## PRODUCT CHANGE NOTIFICAT

## **Automated Assembly Process and Uniform Die Size** for Select Bourns® Commercial Grade TVS Diodes

Model SMCJ, 1.5SMC and SMLJ Series

ESD2034

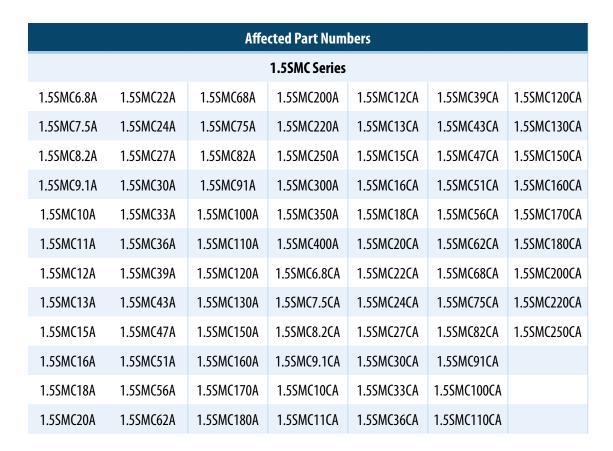
The changes will affect the form of the product, as depicted below. With the new process, tie bars will be visible at the side of the package, but there is no internal connection between these tie bars.
